# Windsor Substation Project

## Final Mitigated Negative Declaration

## **Pacific Gas and Electric Company's Windsor Substation Project**

**(A.10-04-024)**

Figure 4-4

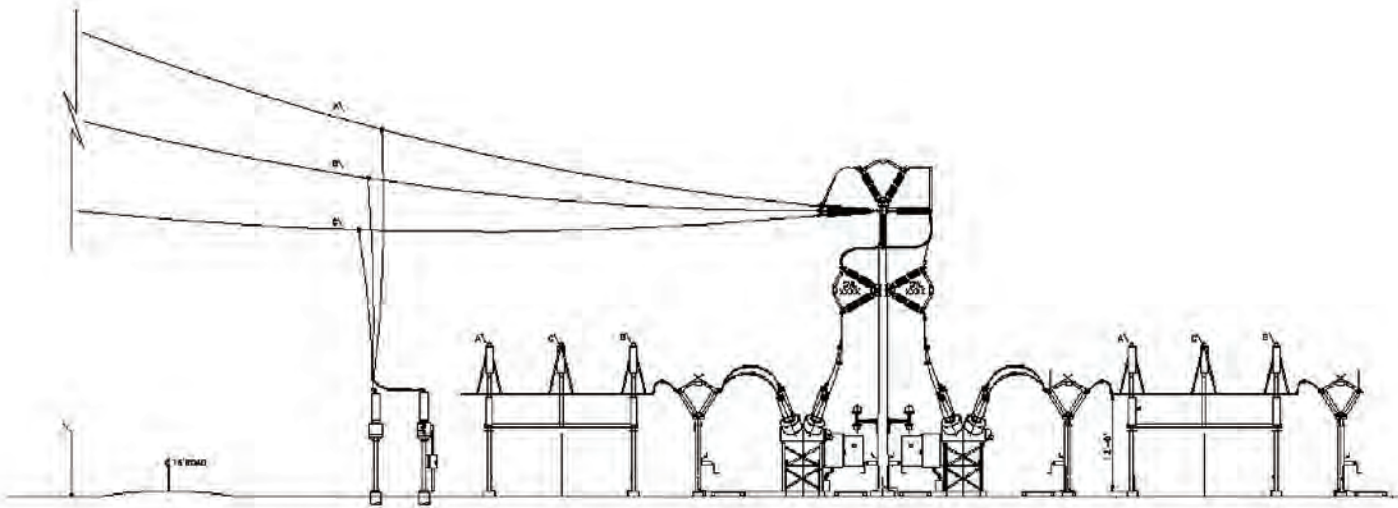
3. **Figure 4-4** is dated PGE 2012. This should be dated PGE 2013.
4. **Page 4-10, Section 4.10.1, last paragraph.** For clarification, water used during construction may be supplied by sources other than the Town of Windsor, including potentially the nearby well adjacent to Herb Road or construction baker tanks.

F1-3 PG&E requests that Figure 4-4 be dated “PG&E 2013” instead of “PG&E 2012.” The figure has been revised as requested for the Final IS/MND.
